Tech Tip

From your friends at New York Bus Sales

Product Affected-All Units

Complaint - Window stops continually break from students “slamming” them open and hanging from them.

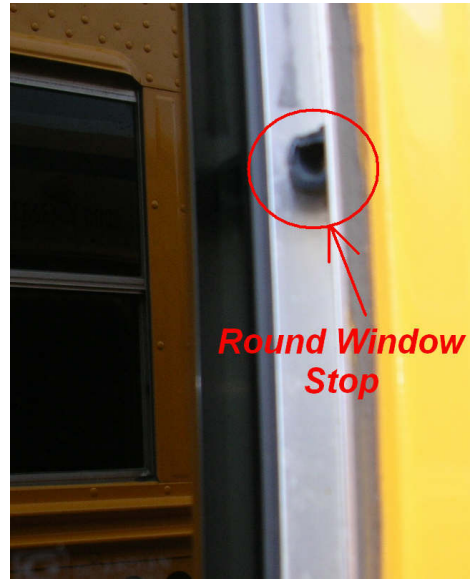
Cause - The “hollow” round stop used in the track on the outside of the split sash window often times does not supply sufficient support over extended periods of time especially when passengers expect the windows to go down all the way but find that for safety purposes they are required to be at 5” maximum opening and may “slam” against the stops in an attempt to open the window further.

Correction - Look at the outside tracks of the windows to find the stops located 5” from the lower edge of the upper sash (Figure #1). As you can see in the close-up of the stop (Figure #2) the stop has begun to become distorted.....To the point that it will end up missing (Figure #3) which will cause the window to become cocked and worse allow it to open over the 5”NYSDOT required minimum.

What has been shown to us is that using the original aluminum “block” style stops that were on the inside of the previous window (Figure #4) will better ward off the stress exerted on the window. Figure #5 shows one installed in an original Blue Bird window.

Locate the inner track (Figure #6) of the window and measure so your opening does not exceed the 5” minimum, drill a 3/16” hole and using a #6 x 3/8” pan head screw install the block.

Figure #7 shows how nicely this block fits in the track of the new style window.
